ADDENDUM NO. 1

CRANDALL ISD – PERFORMING ARTS CENTER ADDITION TO CRANDALL HIGH SCHOOL

AUGUST 26, 2024

Inp project
DLR23073
sheet
C1.08

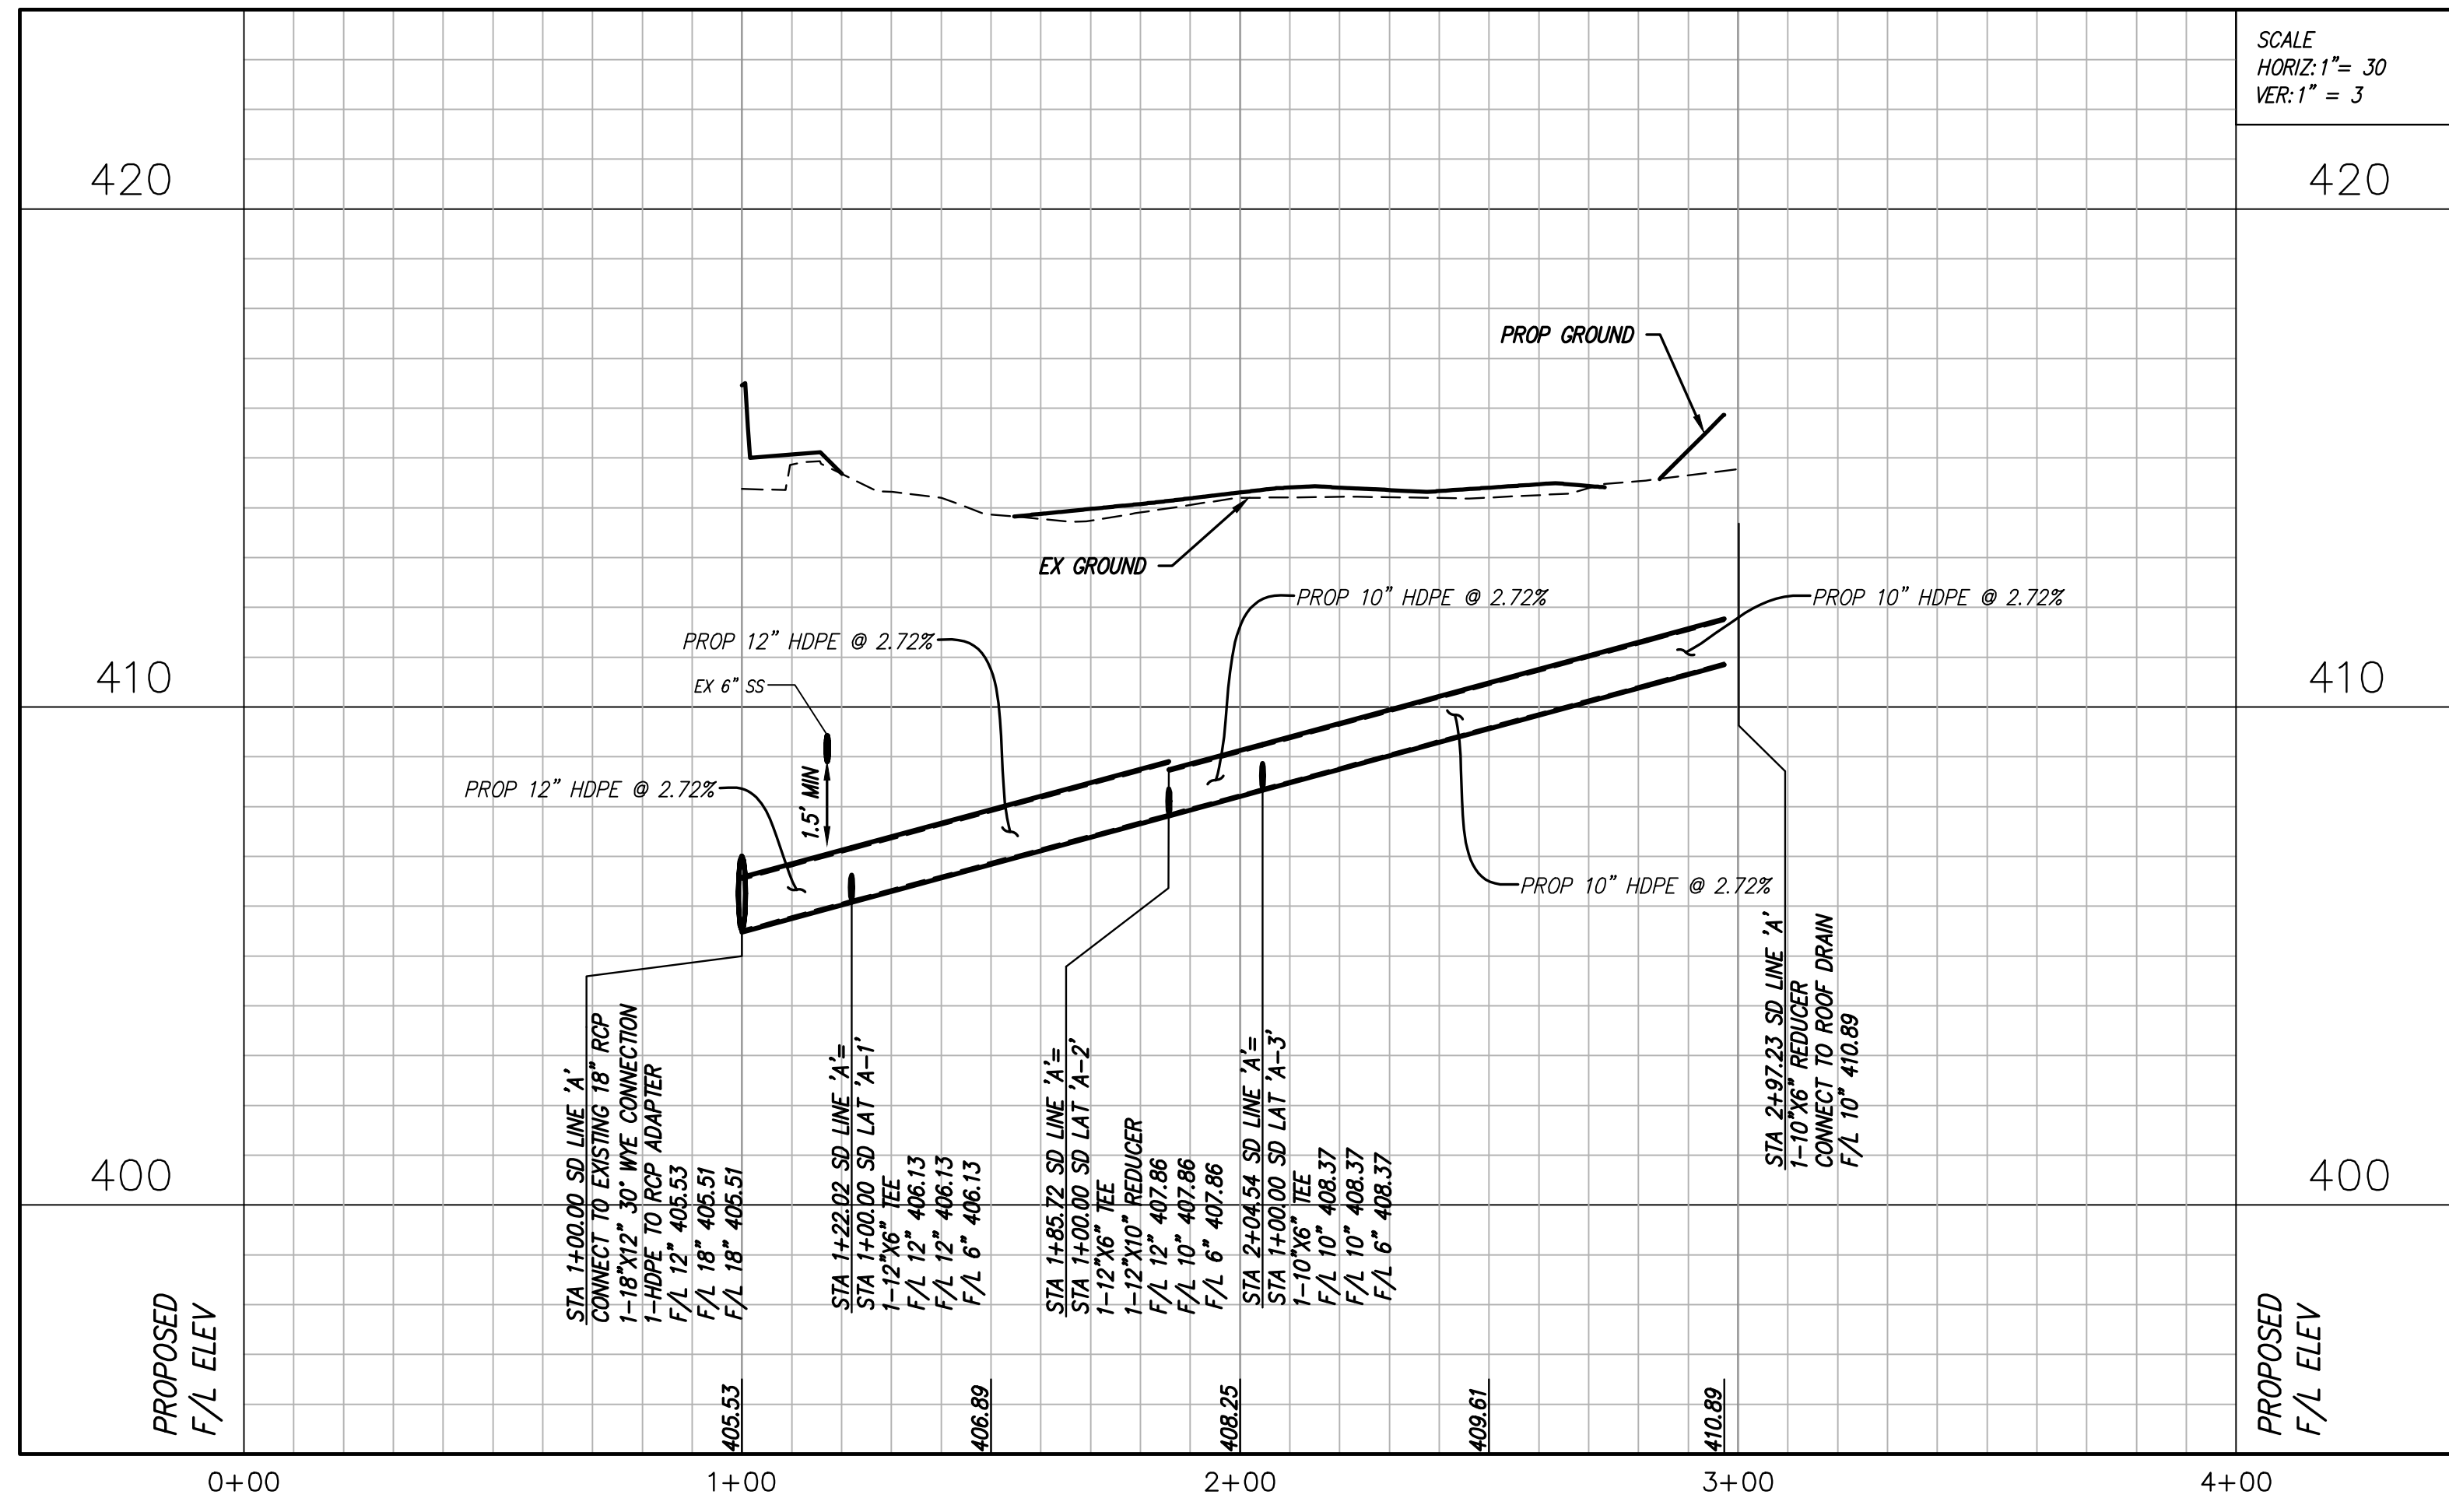
- ITEM 13. C1.08 – STORM DRAIN PLAN – has a revised storm drain plan as indicated on the re-issued sheet.
- ITEM 14. C1.09 – STORM DRAIN PROFILES – SD Line ‘A’ and SD Line ‘B’ have been revised as indicated on the re-issued sheet.

tnp project
DLR23073
sheet
C1.10

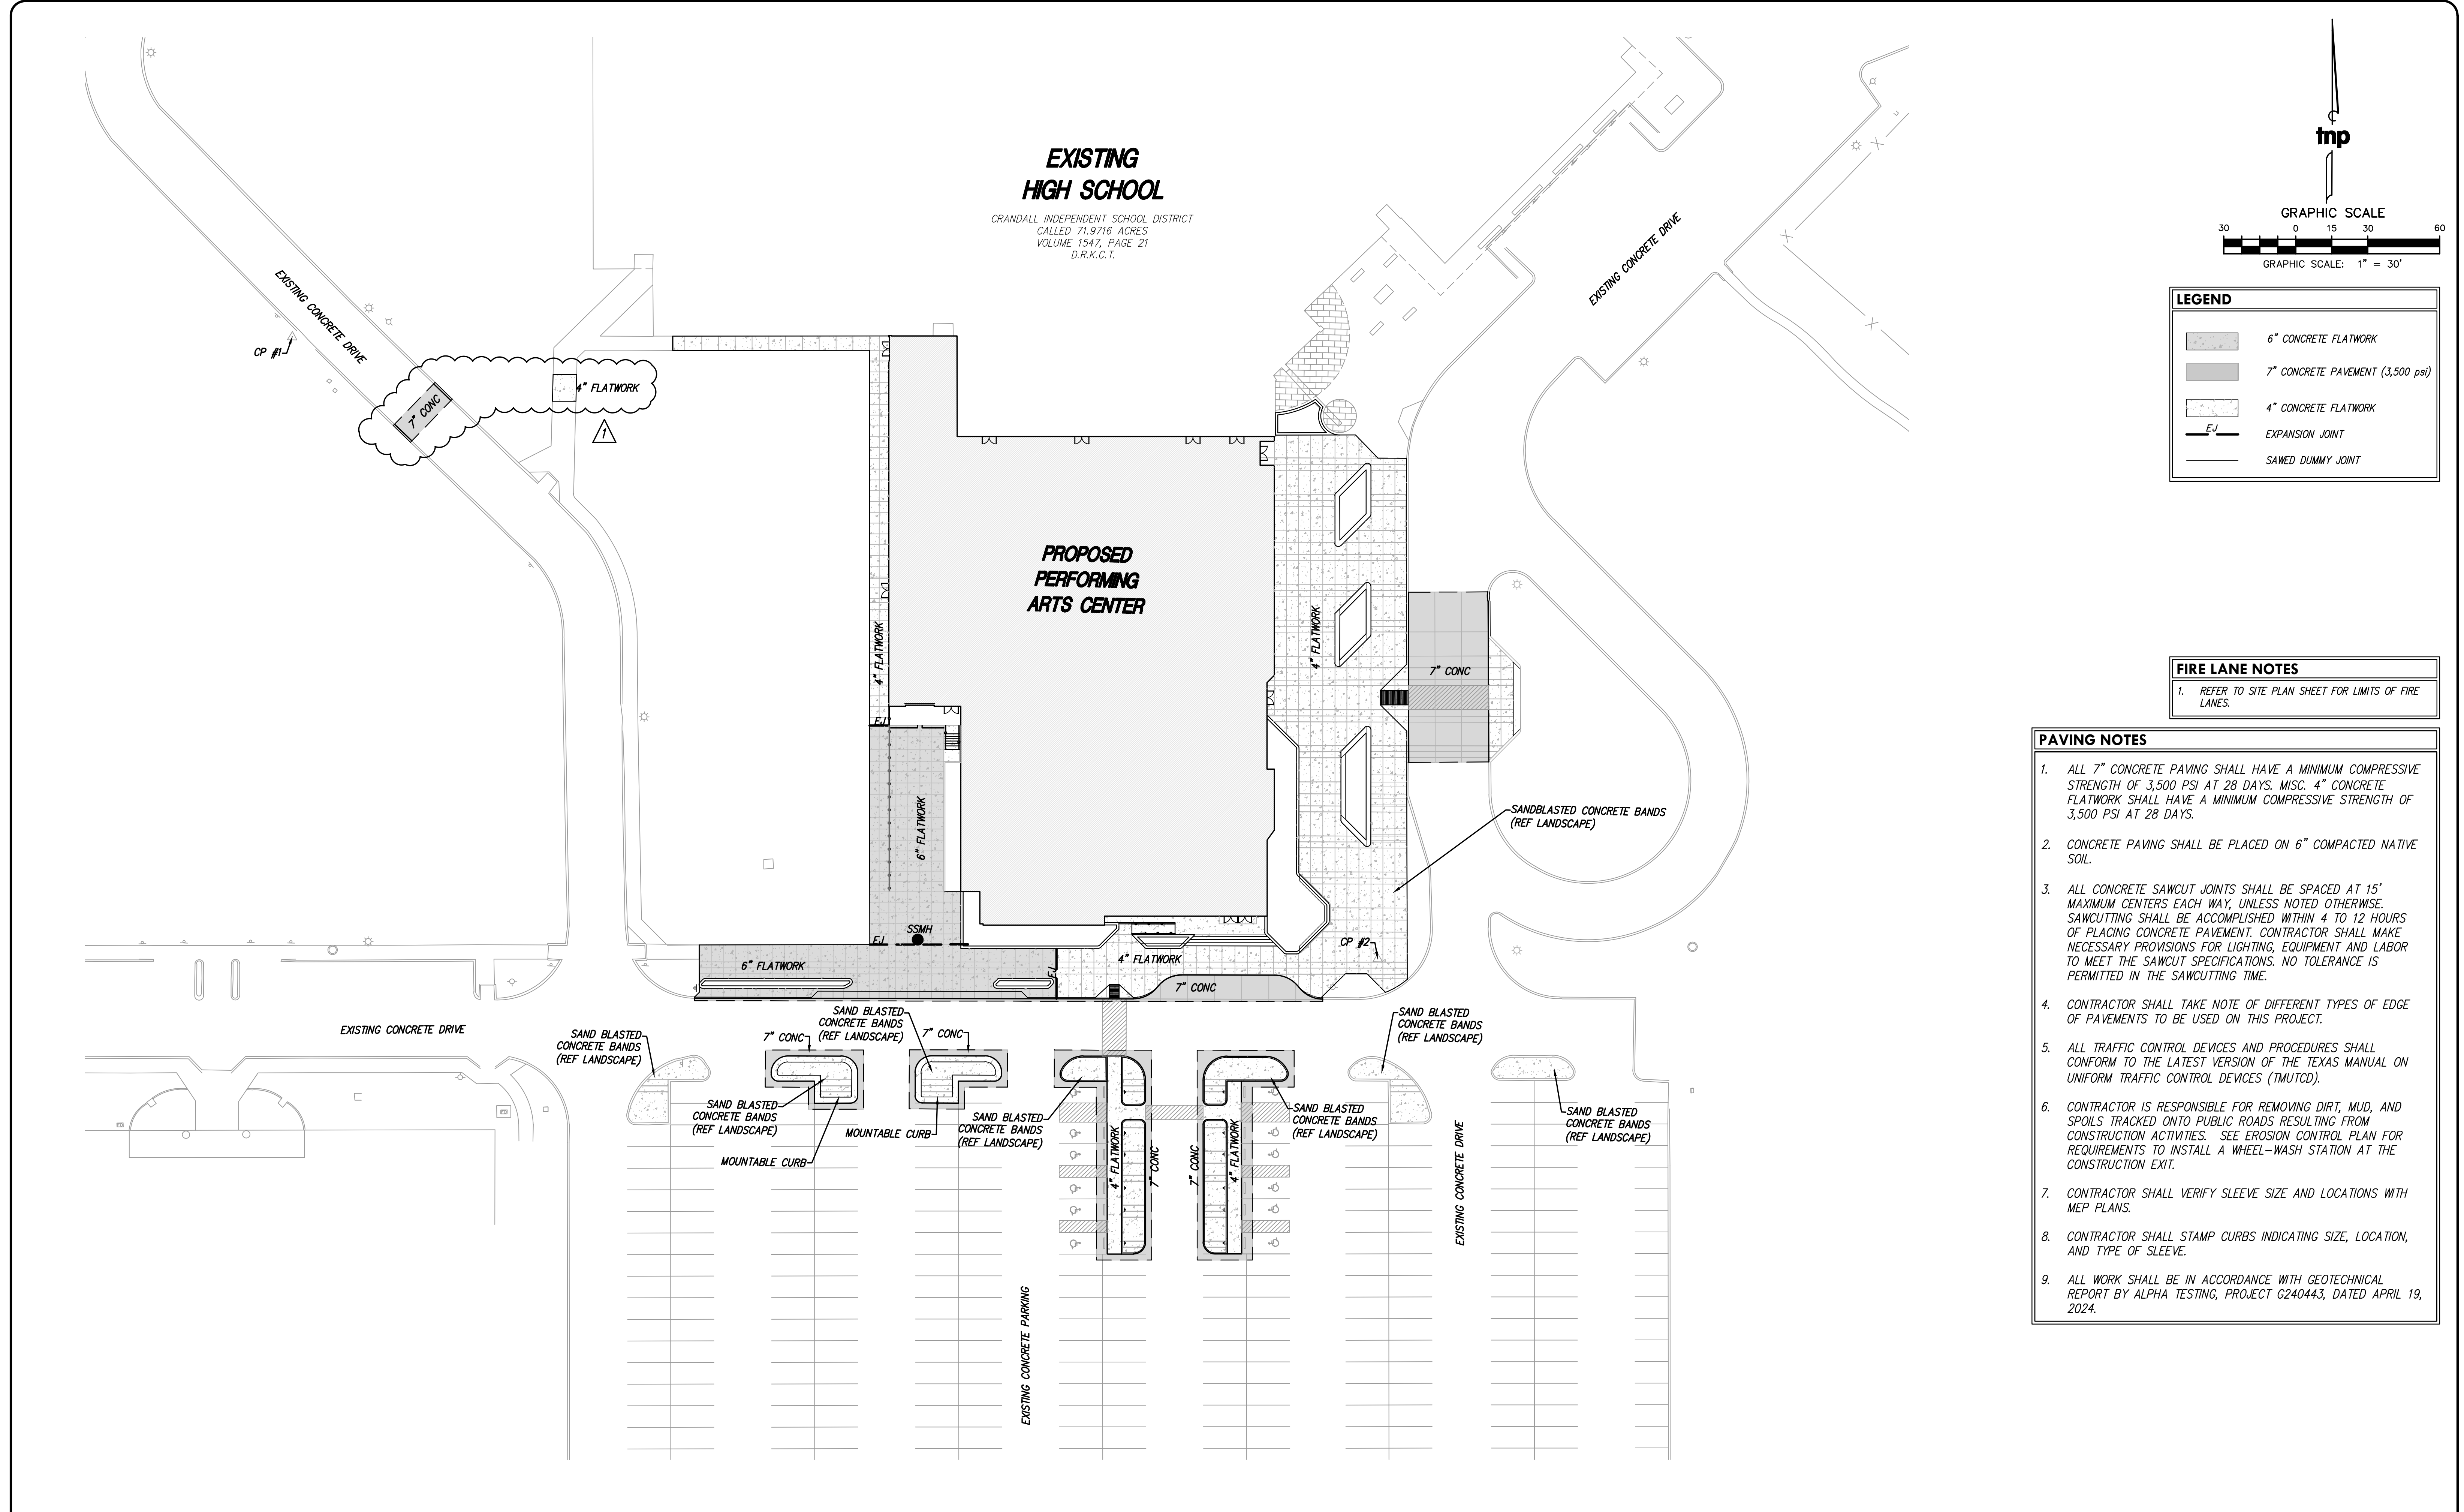
- ITEM 15. C1.10 – SANITARY SEWER & WATER PLAN – has been revised to reflect the fire line and FDC line as indicated on the re-issued sheet.
- ITEM 16. C1.11 – PAVING PLAN – has been revised to reflect replacing paving where the fire line and FDC line disturbed existing conditions as indicated on the re-issued sheet.

tnp project
DLR23073
sheet
C1.18

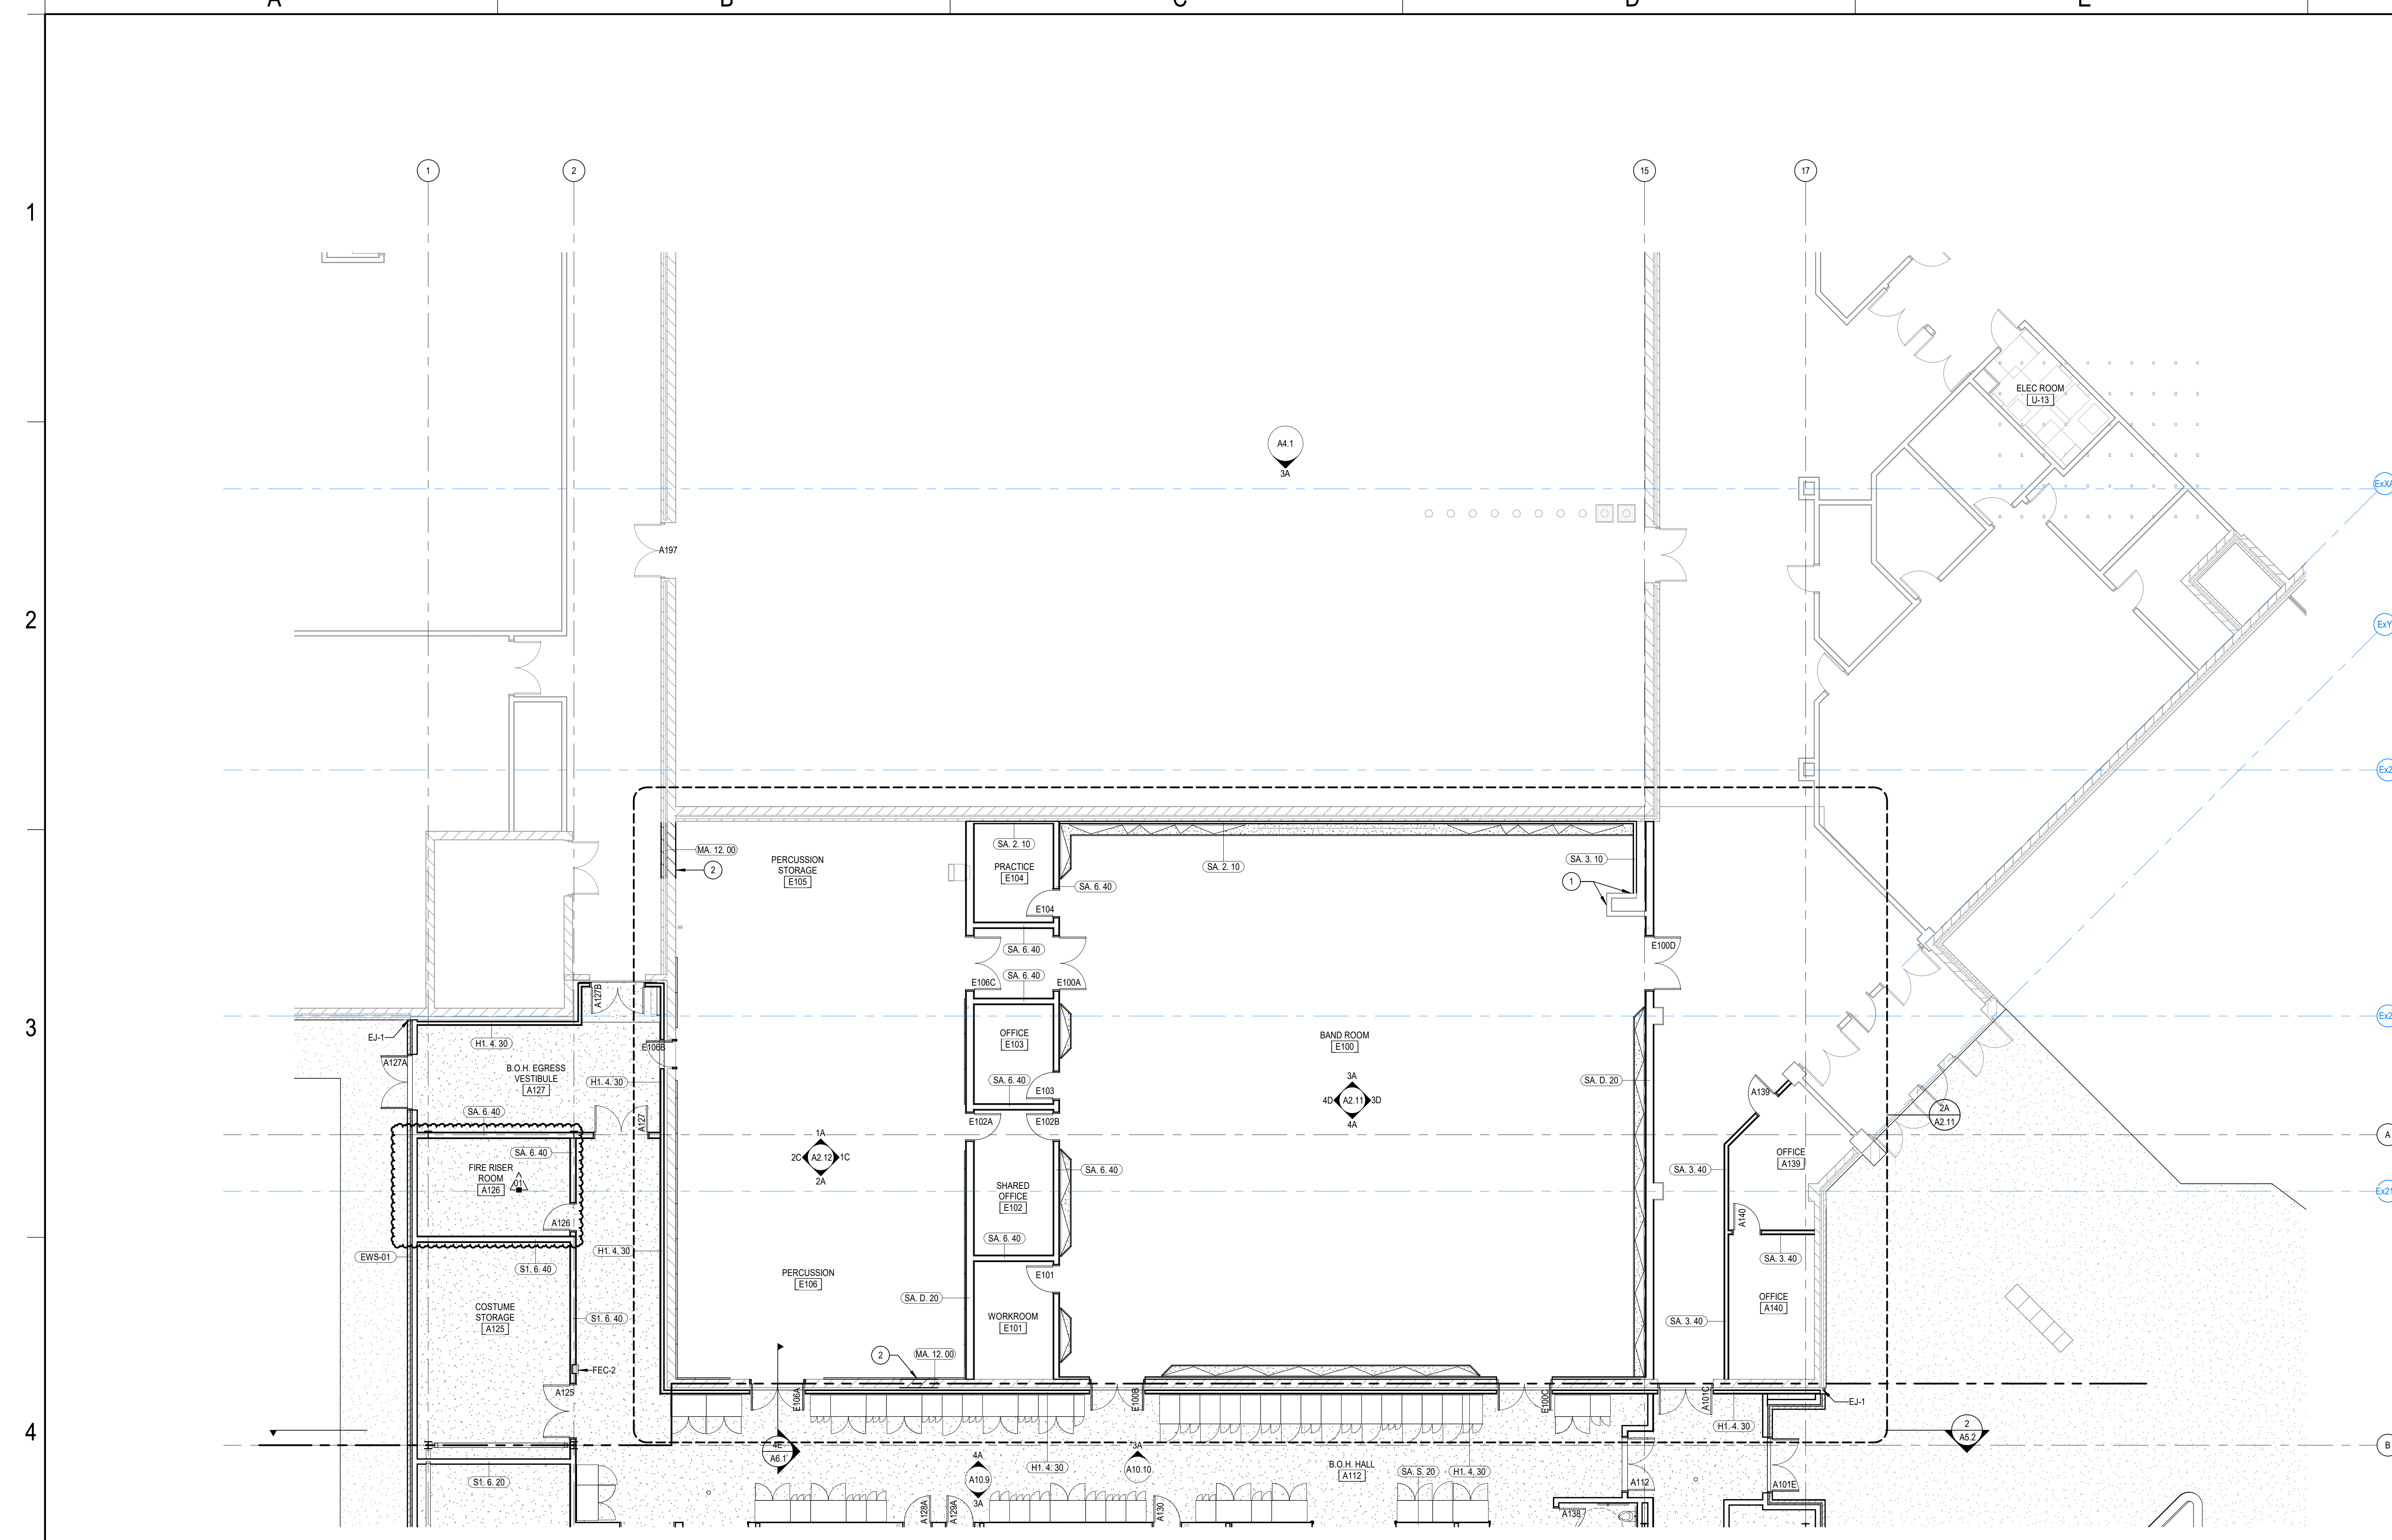
- ITEM 17. The Drawing Set has been revised to include C1.18 – WATER DETAILS – New details added to include Thrust Block Detail, Pavement Cuts Removal and Replacement, and Gate Valve 4” to 12” Box & Extension Stem. This sheet has been issued in its entirety.
